Sumter City-County Planning Commission

March 28, 2012

MSP-12-09/HCPD-12-07, 2542 Broad St. – Scott Will Toyota (City)

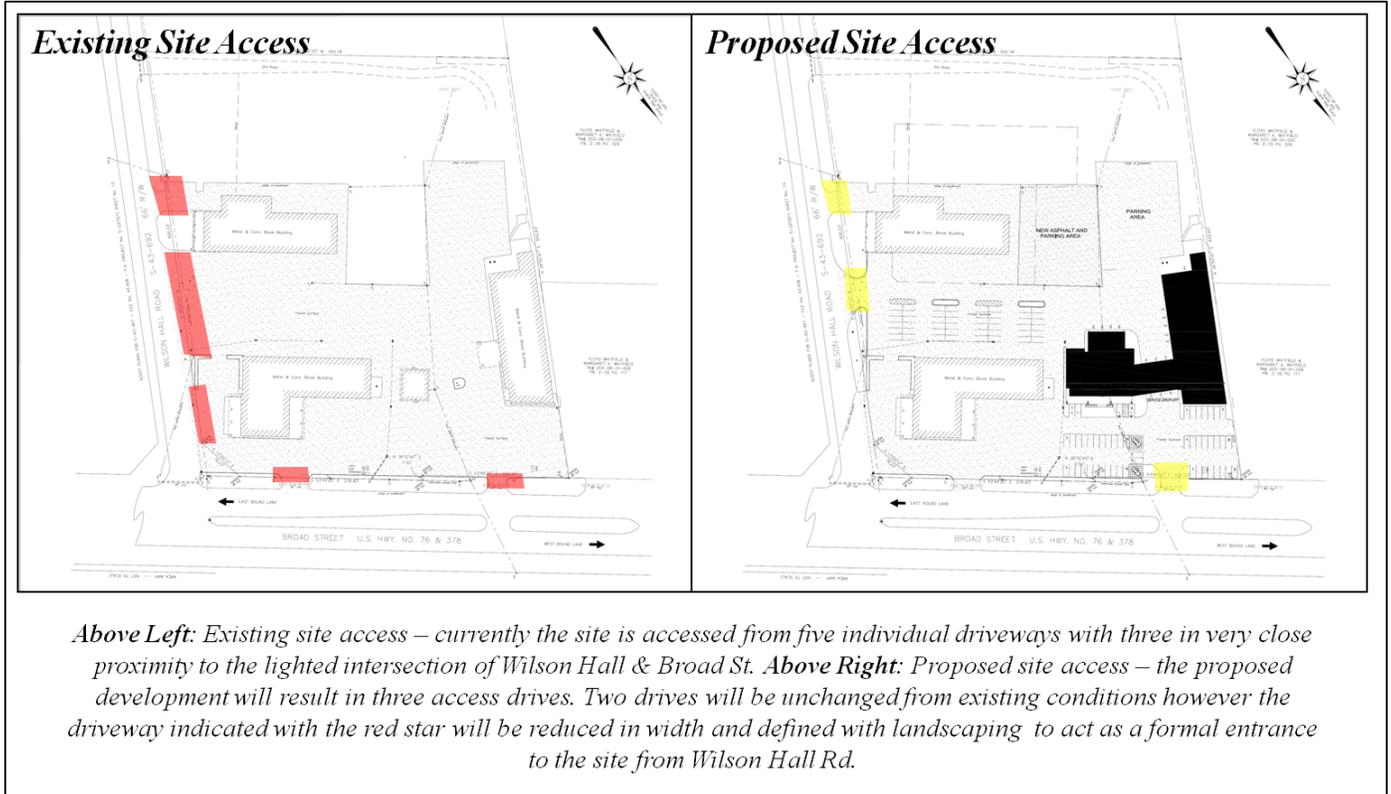
There are no trees or existing landscaping currently on site. The applicant has submitted a landscape plan that addresses landscaping for the new parking area as well as street front buffering.

The Landscape plan depicted above shows the areas proposed for planting. The red dotted line indicates proposed/existing chain link security fencing for the Collision Shop/towing holding areas while the orange dotted line indicates the traditional 3 1/2ft. tall white pipe fencing commonly seen around car display areas at dealerships.

Chain link fence already exists on site. The landscape plan has been designed to obscure the fencing along the Wilson Hall Rd. frontage. No chain link fencing will be visible from the Broad St. frontage.
